ADDENDUM NO. 1

This addendum includes Item Number 1-1 thru 1-76. This addendum item shall be fully incorporated into the Bidding/Contract Documents and have the same force and effect as though originally included.

Life Sciences Collaboration
1910 N. Antelope Valley Parkway
Lincoln, Nebraska
TCEP No.: 716-002-12
Davis Design.: 12-0077
BVH No.: L12018.unl
November 27, 2013

Item 1-38: Sheet A1.32 - Third Floor Reflected Ceiling Plan – Area A

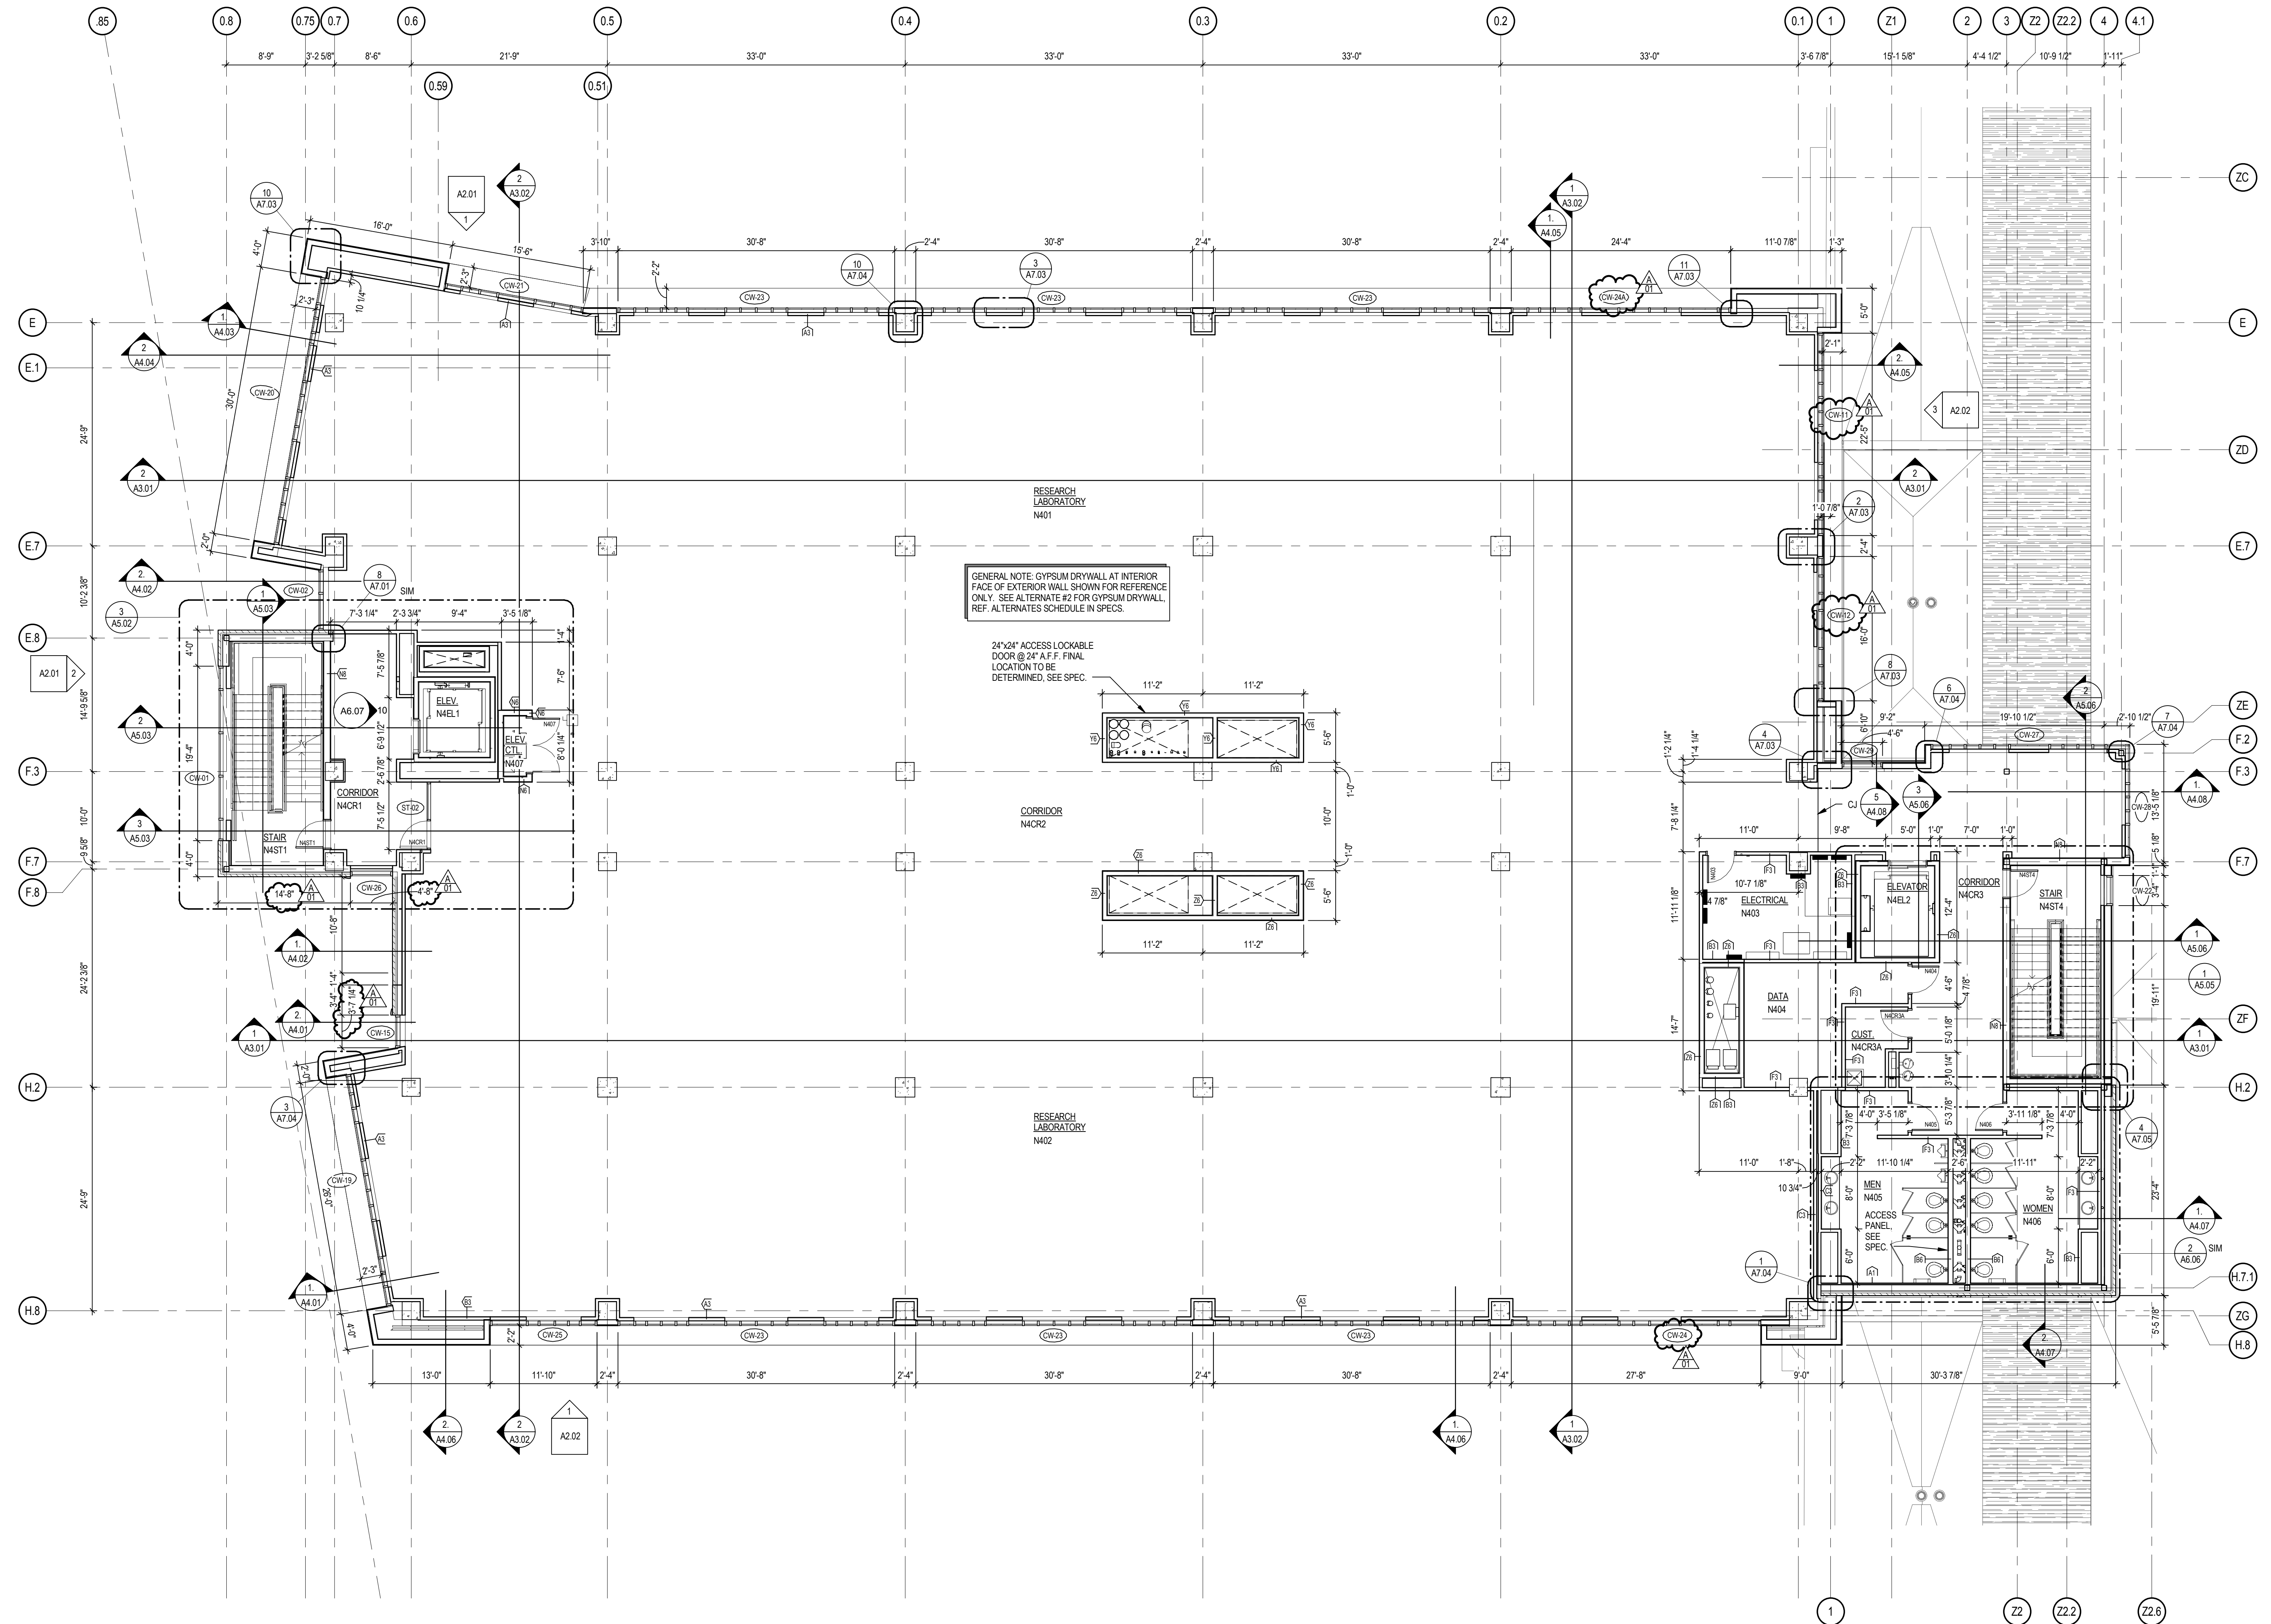
See revised sheet for updated Ceiling at corridor N3CR1.

Item 1-40: Sheet A1.42 – Fourth Floor Reflected Ceiling Plan – Area A

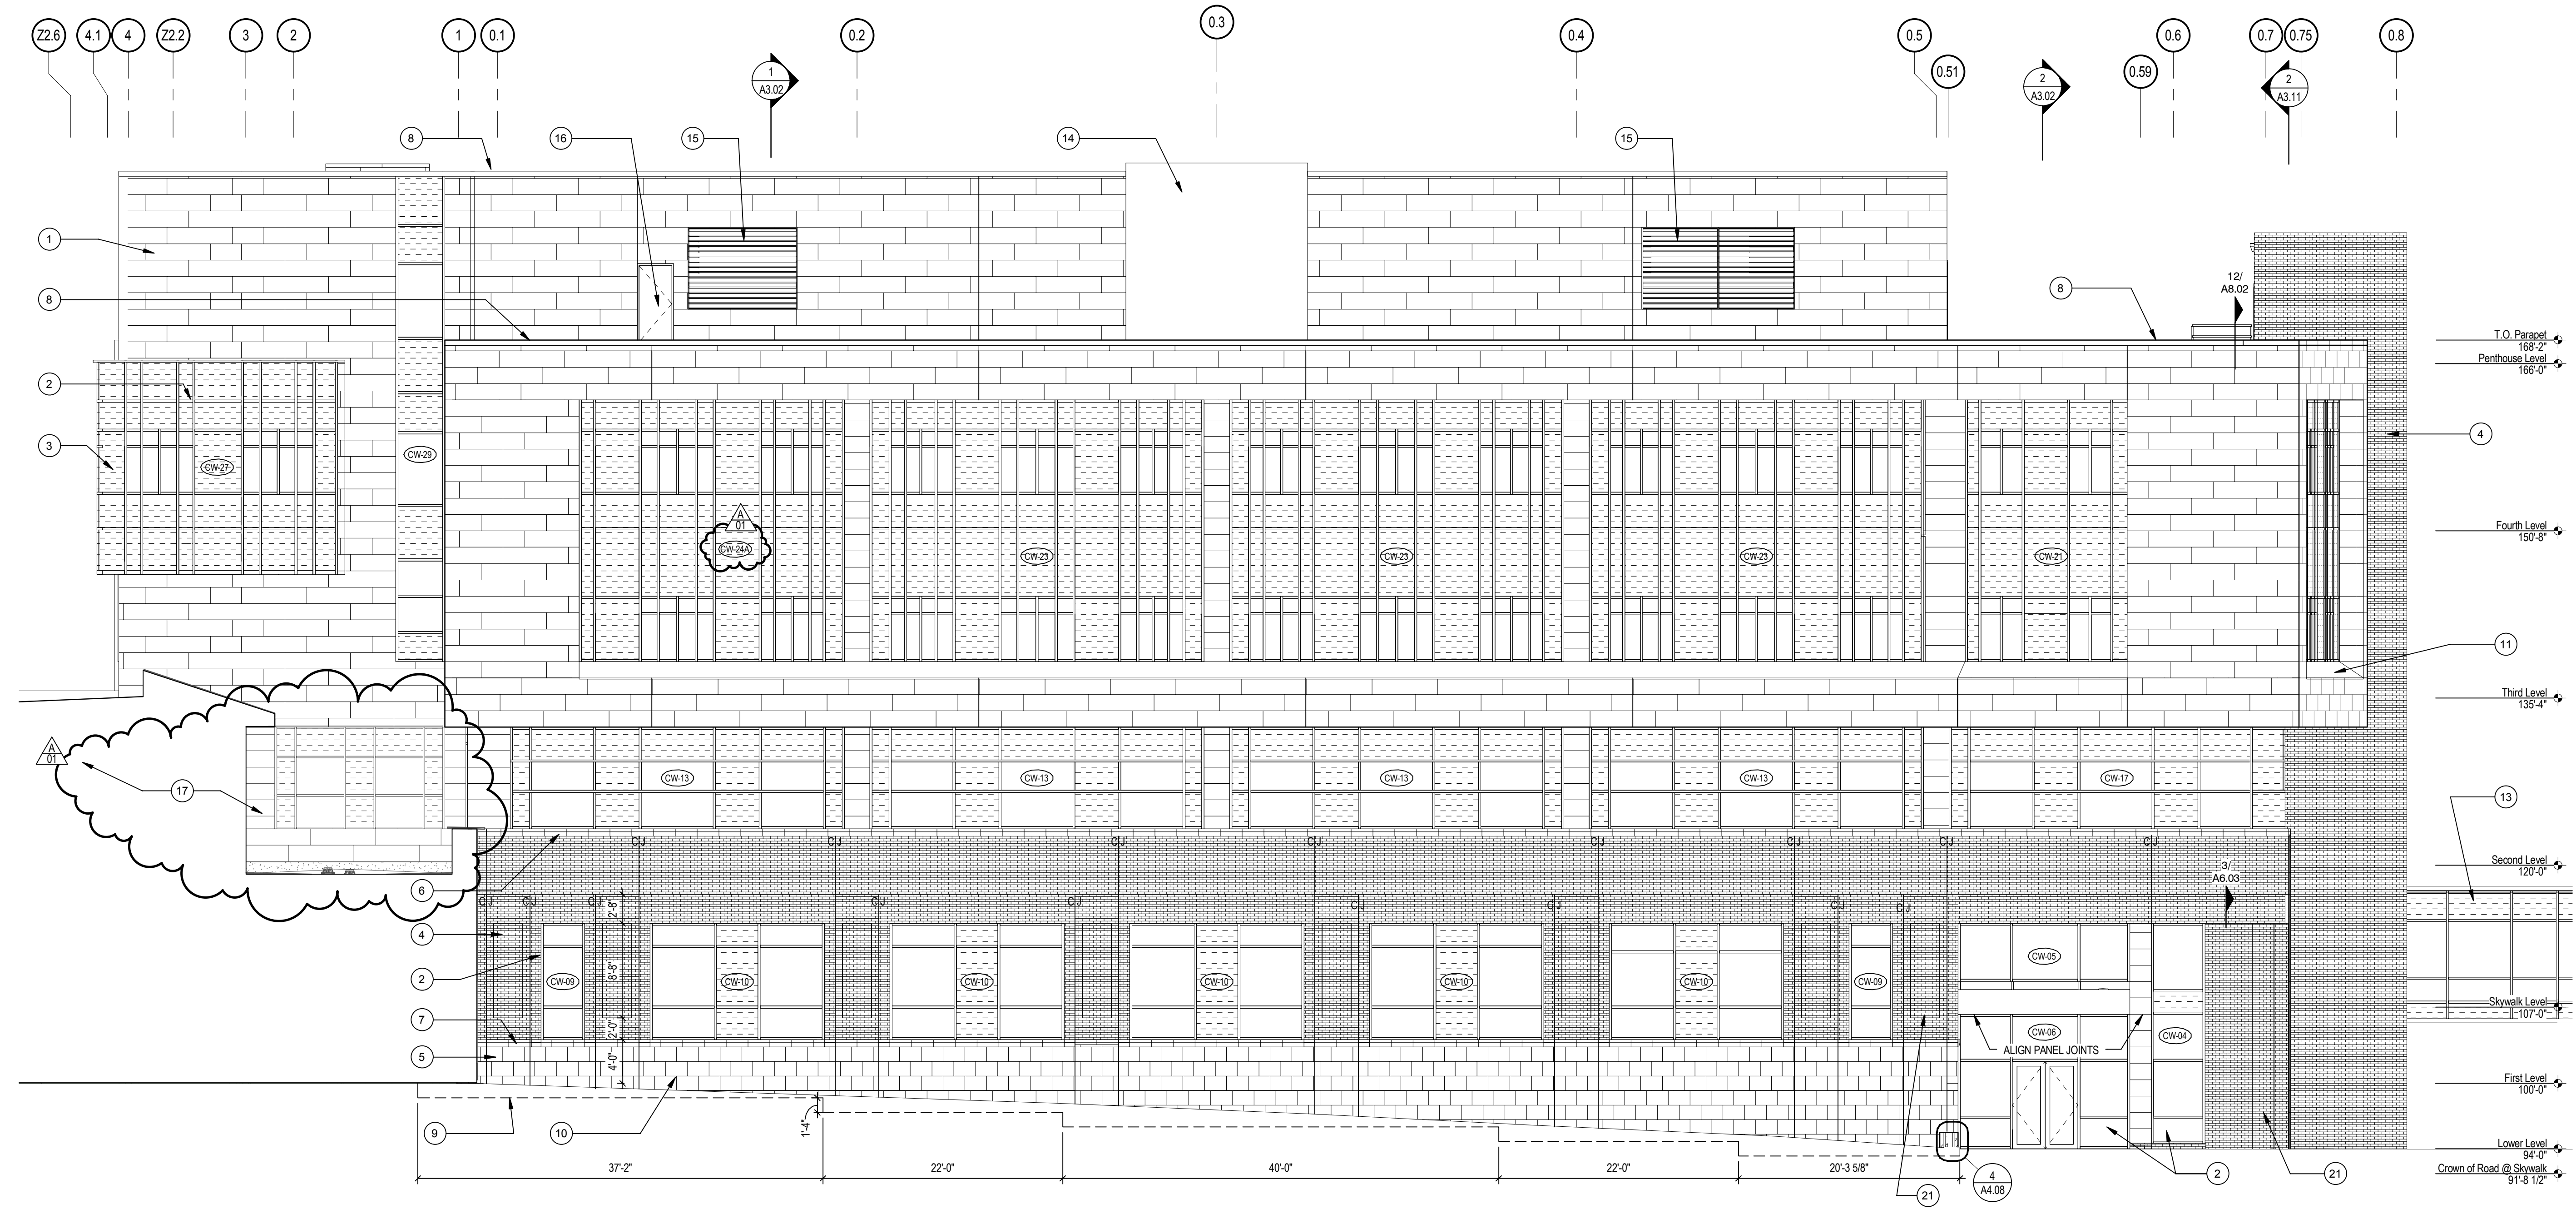
See revised sheet for updated Ceiling at corridor N4CR1.
